# Charlotte Department of Transportation

## Memorandum

**Subject:** Rezoning Petition 15-047: Approximately 22 acres located on the east side of Macfarlane Boulevard near the intersection of North US 29 By-Pass Highway and North Tryon Street.

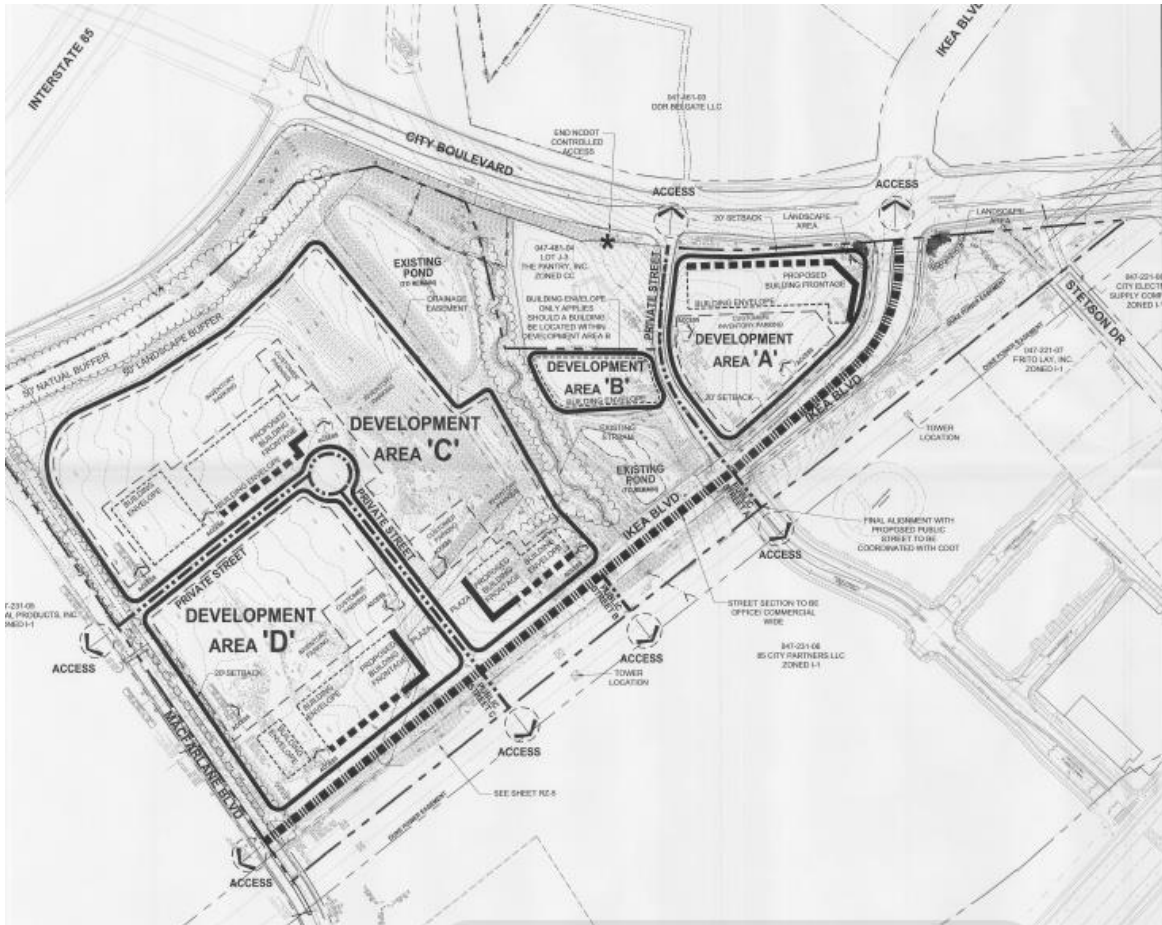
1. Rezoning petition 2013-052 CD plan across Ikea Blvd. from the site calls for a third (3<sup>rd</sup>) public street, halfway between Periwinkle Hill Dr. and this petition's western most public street. We realize topo and/or environmental constraints may make building a public street difficult, however CDOT would support implementing a private network street or perhaps a driveway to distribute traffic within the site (see petition 2013-052 approved site plan below).
